**CITY OF NOVI CITY COUNCIL  
OCTOBER 10, 2022**

**SUBJECT:** Consideration of the request of Cambridge of Novi, LLC for a Second Amendment to the previously-approved Planned Rezoning Overlay (PRO) Agreement, JSP 17-52 and JSP 21-12, Terra, associated with Zoning Map Amendment 18.718. The applicant received approval for a 41-unit single-family ranch development on approximately 30.14 acres on the north side of Nine Mile Road, east of Napier Road. The current amendment is requested to make changes to sidewalks in the Phase 2 portion of the project.

2<sup>nd</sup> Amendment to the PRO Plan & Agreement (JSP17-52) and 2<sup>nd</sup> Revised Final Site Plan (JSP21-12)

**WOODLAND TREE RELOCATION PLAN**

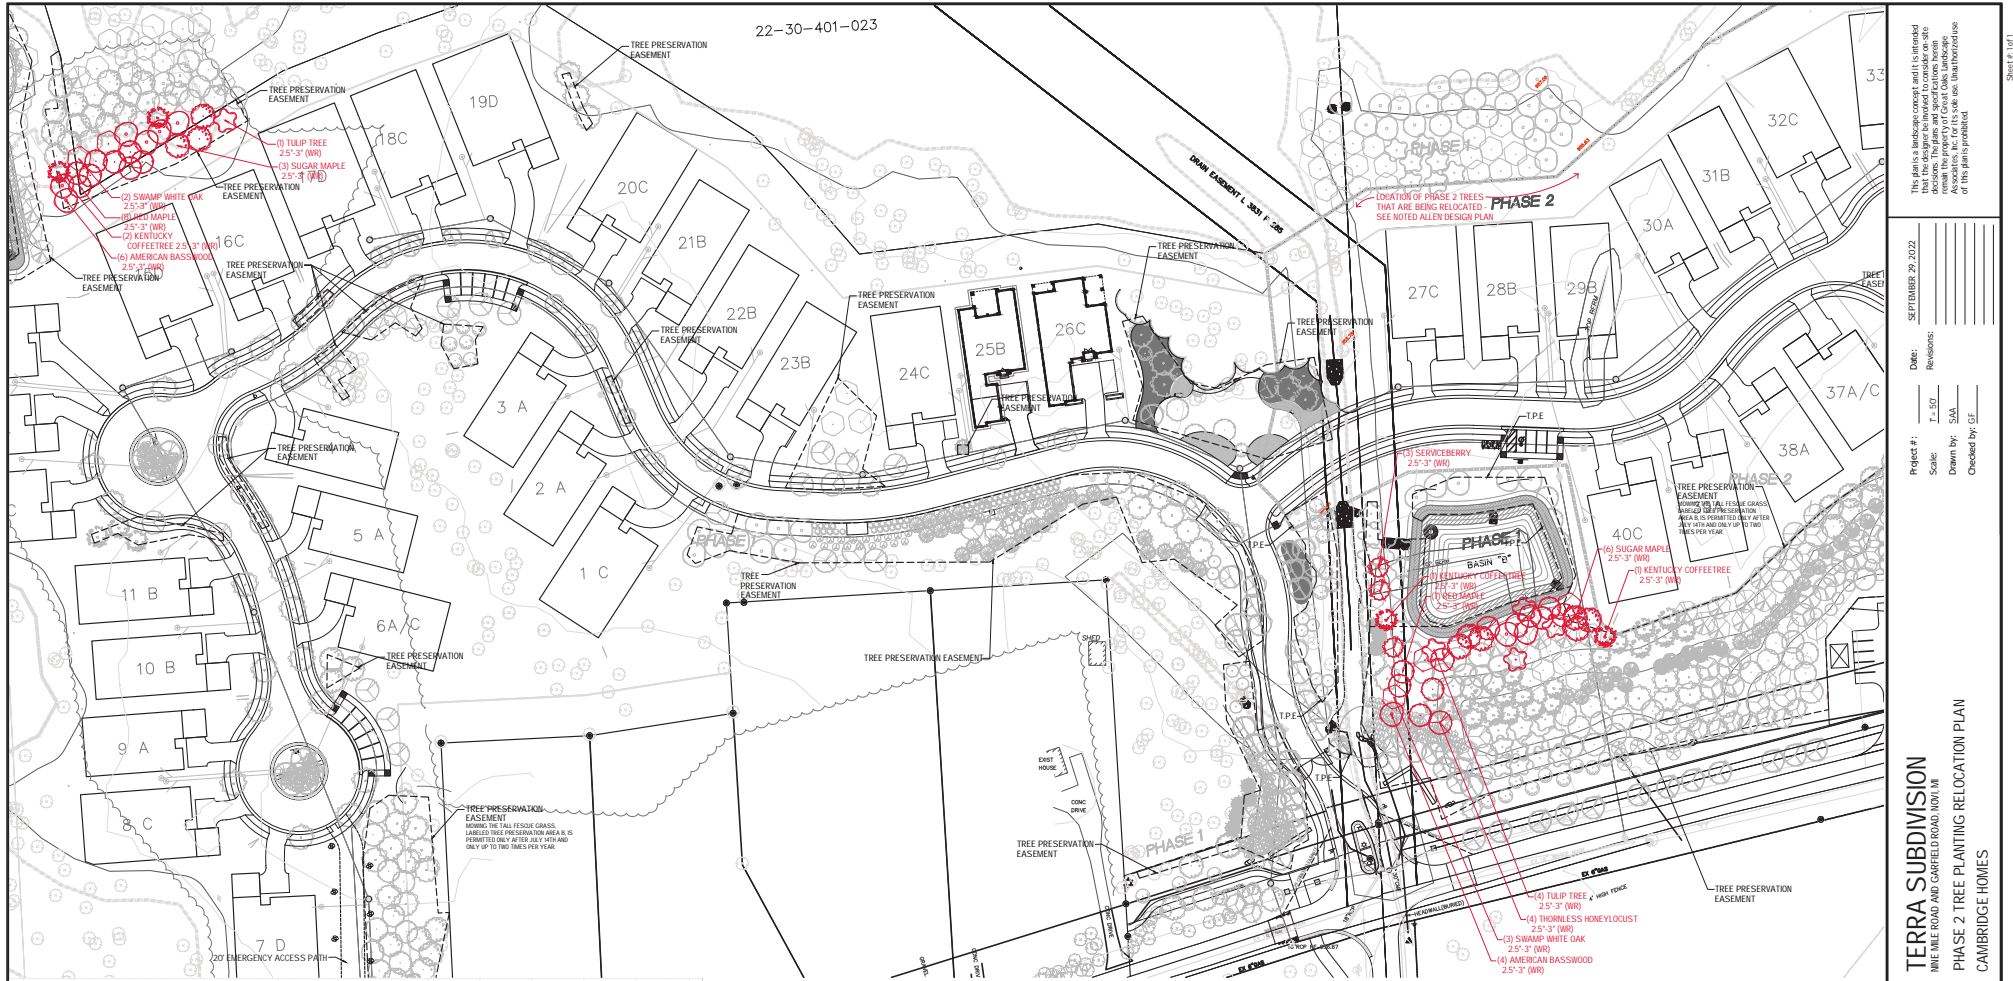
3. **Woodland Trees:** When the Phase 2 site plan was approved the applicant had shown 51 woodland replacement trees to be planted beside and behind units 27-36. The applicant would instead like to pay into the Tree Fund rather than planting the replacements on the site. The applicant states the proposed trees were going to be too close to the homes. Staff has worked with the applicant to identify alternative locations on the property to plant the trees. **Therefore, this portion of the request has been resolved and the PRO Agreement does not require amendment for this item.**

3. The applicant will work with City staff to locate woodland replacement trees in alternative locations on the site whenever possible and ensure their protection within a conservation easement. Payment into the Tree Fund in accordance with the terms of the Woodland Ordinance shall be made only when on-site planting is not possible, as determined by the City Planner.

Figure 1: PRO Agreement, Exhibit B, Sheet 4, Liber 52674 Page 562

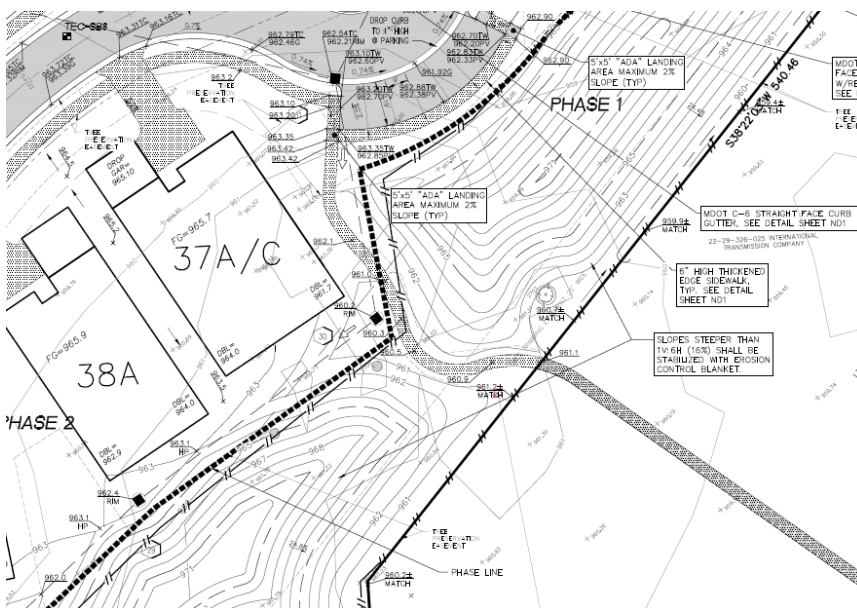
1. Sidewalk Connection to ITC Corridor: The PRO Agreement states on Page 4, Item 6: "The applicant will work with staff to identify a proper location to connect to ITC trail, beyond the subject property line." The 5-foot wide asphalt sidewalk is shown on the PRO Plan in Exhibit B of the Agreement, and in the Phase 2 site plan. The applicant states the residents of the development would like to eliminate the sidewalk connection in order to continue the berm to provide additional screening of the ITC transmission towers, as well as to limit pedestrian traffic into the community. They have provided letters from several current and future residents that echo support for eliminating the connection. They also point out that the sidewalk at the main entrance provides a connection to the ITC Trail.

Figure 2: Phase 2 Final Site Plan, 2/3/2021

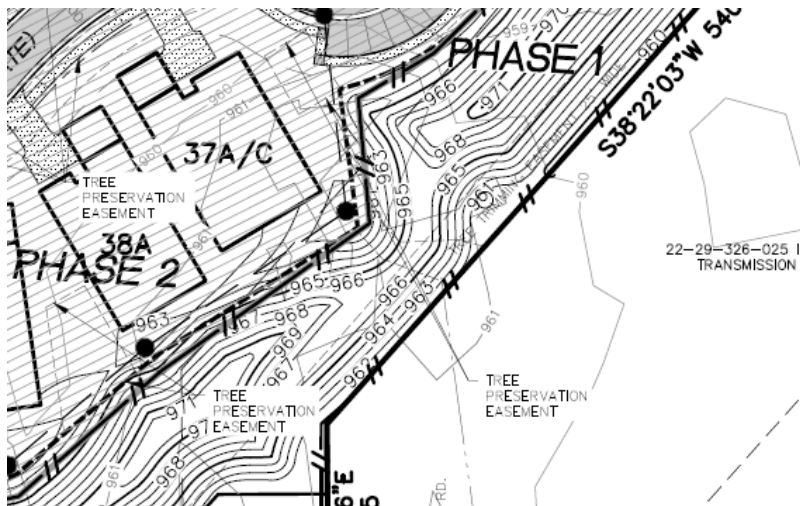
While the connection to the ITC Trail is not a requirement of the Zoning Ordinance, its inclusion in the original PRO Plan and Agreement appeared to be presented as an amenity to the community. However, it was not specifically mentioned as a “public benefit” per say or stated as a requirement. Staff prefers the segment be provided in the interest of enhancing non-motorized connectivity throughout the community.

Figure 4: Original sidewalk plan, June 2021

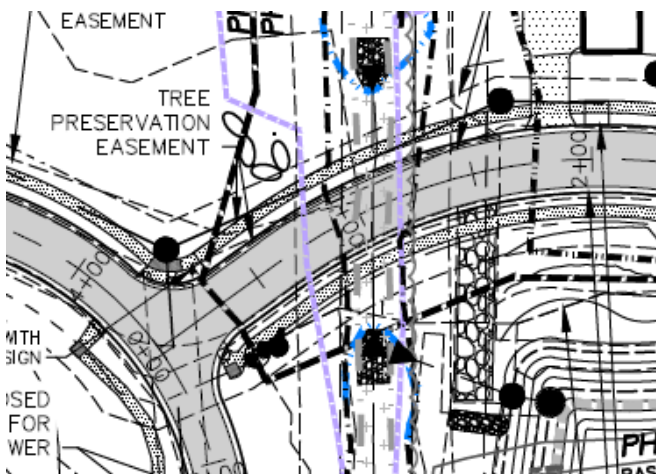
2. Sidewalk on Villa Court: The Subdivision Ordinance (Section 4.05) and the Design & Construction Standards (Section 11-256(b)) both state that sidewalks shall be provided on both sides of proposed drives. The applicant received a deviation in the original PRO Agreement to not provide a sidewalk on the east side of the main entrance drive (Villa Drive) due to the presence of wetlands, with a payment to the sidewalk fund required in lieu of building it. The applicant now requests a deviation to remove a portion of the sidewalk on the south side of Villa Court. During construction of the culvert for the Garfield Drain, the decision was made by on-site engineers to shift it to the north a few feet to avoid eroding soils over time. This change created a narrower space between the road and the slope to the culvert to place the sidewalk as shown on the original plan. Staff was made aware of the change and encouraged the applicant to work with their engineers to try to fit the sidewalk by moving it closer to the road or by building a retaining wall. The current plan shows the sidewalk ending on the south side of Villa Court about 110 feet east of the intersection with Villa Drive, with ramps provided to enable pedestrians to cross the street to connect to the north side sidewalk. No crosswalk markings are proposed. **Staff recommends the applicant adhere to the Code to provide the required sidewalk. Based on the plan it still appears feasible to fit it between the road and the culvert.**

Figure 5: Phase 2 Landscape Plan, June 1, 2021

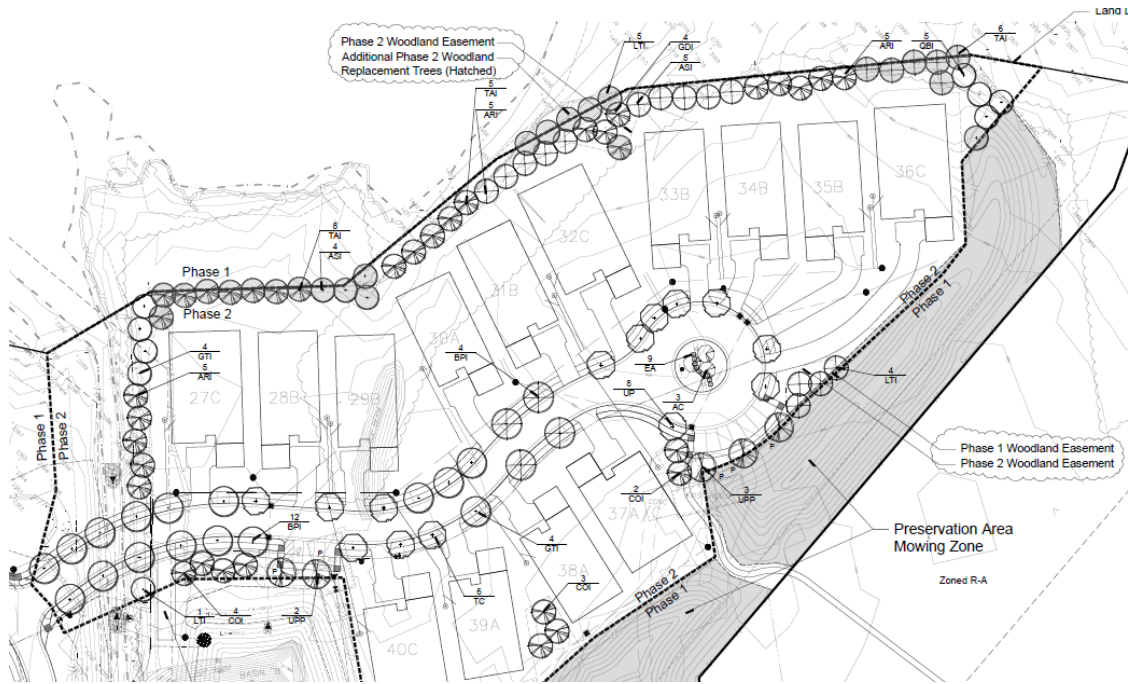
3. **Woodland Trees:** When the Phase 2 site plan was approved the applicant had shown 51 woodland replacement trees to be planted beside and behind units 27-36. The applicant would instead like to pay into the Tree Fund rather than planting the replacements on the site. The applicant states the proposed trees were going to be too close to the homes. **While the Woodland Ordinance permits applicants the option to pay into the Tree Fund, the Woodland Permit from the Planning Commission was approved with the understanding that the credits would be planted on-site. It also appears there would be additional locations on the property where woodland trees could be planted, as noted in the Landscape Review.**
